Access Compliance Report

Public Rights-of-Way

(Curb Ramps)

Intersection ID: 28976	Main Street: BANNINGTON_RD	Cross Street: CARMEL_COMMONS_BV	Location: SW
ADA ID: 35691446632F	Ramp Type: PerpDiag	Initial Pass/Fail: Fail	Overall Compliance: No
Severity Score: 33.75			
Codes/Mitigation Info/Possible Solution		Field Measurements/Component Compliance

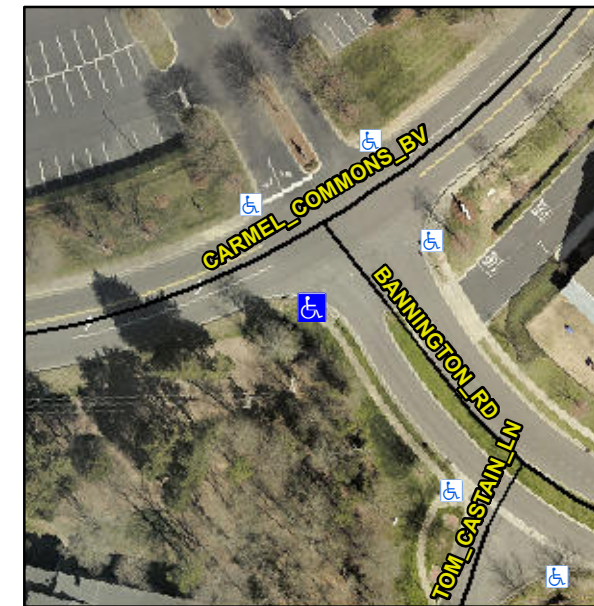
R304.5.1, R304.5.3

Compliance	Description	Data	Compliance	Description	Data
N/A	Ramp Length (in)	96.0	Yes	Ramp Slope (%)	6.5
No	Ramp Width (in)	41.0	No	Ramp XSlope (%)	10.6
N/A	Flare Type LT	N/A	N/A	Flare Type RT	N/A
N/A	Flare Slope LT (%)	N/A	N/A	Flare Slope RT (%)	N/A
N/A	Flare Traversable LT?	N/A	N/A	Flare Traversable RT?	N/A
N/A	Landing Length (in)	N/A	N/A	DWS Provided?	N/A
N/A	Landing Width (in)	N/A	N/A	DWS Contrast?	N/A
N/A	Landing Slope (%)	N/A	N/A	DWS Length (in)	N/A
N/A	Landing X Slope (%)	N/A	N/A	DWS Full Width?	N/A
N/A	Landing Curb? (Y/N)	N/A	N/A	DWS Offset (in)	N/A
N/A	Shared Landing?	N/A			
N/A	Gutter Ponding?	N/A	N/A	Gutter Slope (%)	N/A
N/A	Gutter Lip Ht (in)	N/A	N/A	Gutter X Slope (%)	N/A
N/A	Painted X Walk1?	No	N/A	Painted X Walk2?	No
	X Walk 1 Direction	To E		X Walk 2 Direction	To N
N/A	X Walk 1 Width (in)	N/A	N/A	X Walk 2 Width (in)	N/A
	X Walk 1 Slope (%)	2.4		X Walk 2 Slope (%)	8.5
	X Walk 1 X Slope (%)	8.6		X Walk 2 X Slope (%)	4.0

Remove & Replace Curb Ramp With Two New Directional Ramps or Equivalent.
